Re: LC 80 – Portland General Electric Company’s 2023 Clean Energy Plan and Integrated Resource Plan
Reply to Staff Round 2 Comments and Recommendations

Enclosed for filing today in the above-referenced docket is Portland General Electric Company’s (PGE) replies to OPUC Staff’s Round 2 Comments and Recommendations on PGE’s 2023 Clean Energy Plan (CEP) and Integrated Resource Plan (IRP).

Figure 1. Cost and risk effects of removing transmission market capacity assumption³²

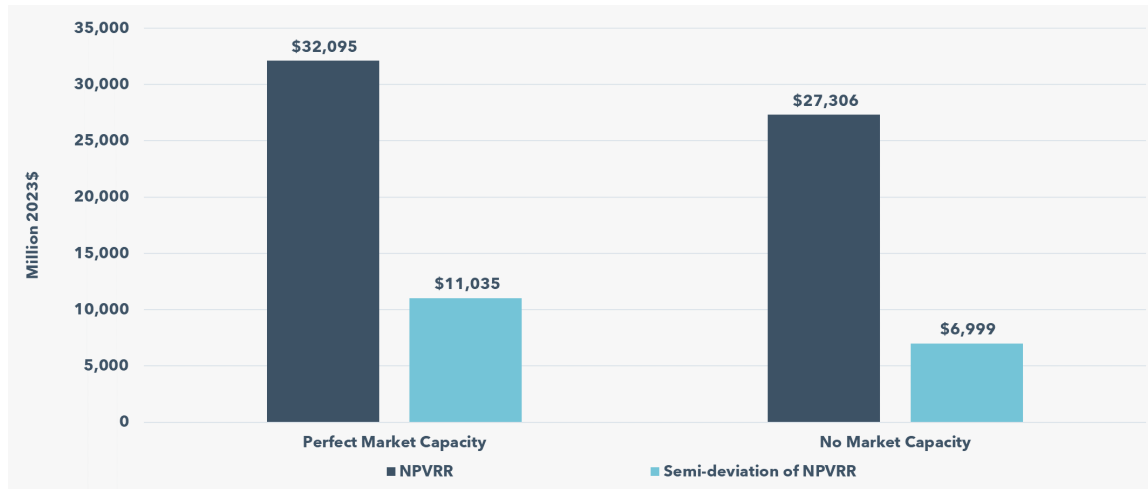
To show the effect of the change in the transmission market capacity access assumption in isolation, PGE modeled the Preferred Portfolio with only the transmission capacity contribution changed and has included the results for informational purposes ('No Market Capacity'). The resource buildout through 2030 of the 'No Market Capacity' portfolio is shown in **Table 1**. Compared to the previous Preferred Portfolio (as described in Section 6.2.4 of PGE's Round 1 Reply Comments), in 2030 the portfolio contains 75 MW more generic VER, 241 MW more storage, and 99 MW less transmission expansion. The increase in storage additions in 2030 suggest that while the model was long on capacity under the previous market access capacity assumptions, when the transmission expansion options provide no market capacity, additional capacity must be added to meet needs.

Figure 1 shows the cost and risk metrics of the 'No Market Capacity' portfolio compared to results under the prior assumptions. Perhaps counterintuitively, removing the market access perfect capacity results in a lower-cost portfolio, reducing NPVRR from \$32.1 billion to \$27.3 billion. Caution should be taken in the interpretation of these results. While this outcome may initially seem counterintuitive because more resources are now needed to meet

capacity needs, the result can be explained by the fact that the cost of both the transmission expansion resources and the generic resources has decreased. The cost of the generic resources is defined as 105 percent of the cost of the NV solar and transmission resource, so a change in the cost of it flows through to the cost of the generics. The decrease in NPVRR associated with the updated assumptions should therefore be viewed as a change driven by modeling constructs, rather than an indication that access to market capacity is not a valuable potential resource in the portfolio.

Figure 2. Cost and risk metrics of the Preferred Portfolio

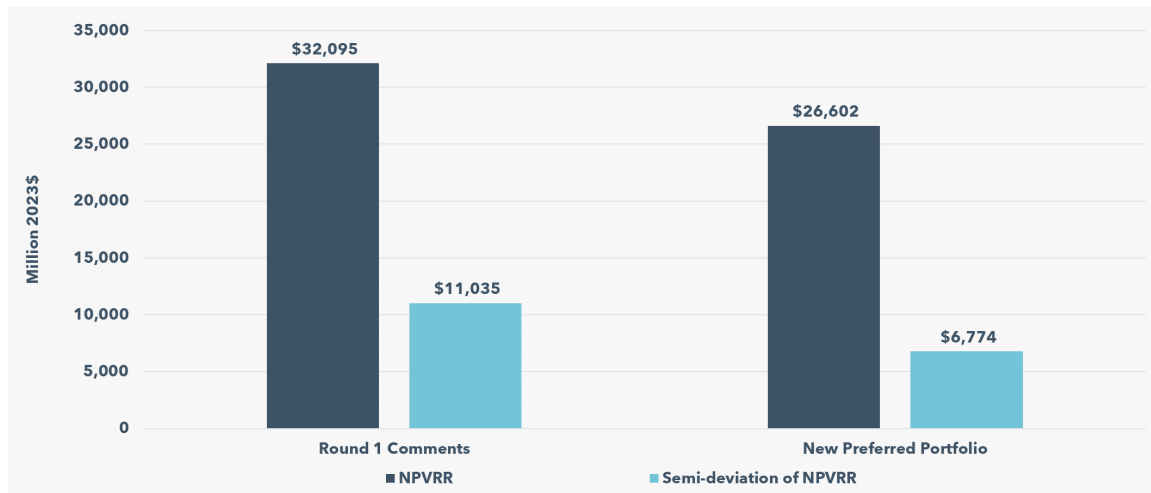
In this section, PGE presents the results of the updated Preferred Portfolio. The updated Preferred Portfolio contains three updates to assumptions compared to the previous version presented in PGE's Reply to Round 1 Comments. The three updates, which are discussed in detail in the preceding sections of this chapter, are:

1. Add 53 MWa EE (see **Section 5.3.1**);
2. Remove the perfect capacity associated with market access for transmission expansion resources (see **Section 5.1**); and
3. Update assumptions about extension of certain hydro and capacity contracts (see **Section 5.2**).

Figure 2 shows the cost and risk metrics of the previous Preferred Portfolio and the new Preferred Portfolio. With the updated assumptions, portfolio NPVRR decreased by \$5.5

billion, driven mainly by a combination of a decrease in overall resource additions because of updated assumptions about contract extensions and changes in the cost of the generic resources (created by the change in assumptions about transmission expansion, as discussed in **Section 5.1**). Cumulative resource additions through 2030 in the Preferred Portfolio are shown in **Table 3**. Changes in 2030 relative to the Round 1 Comments Preferred Portfolio include:
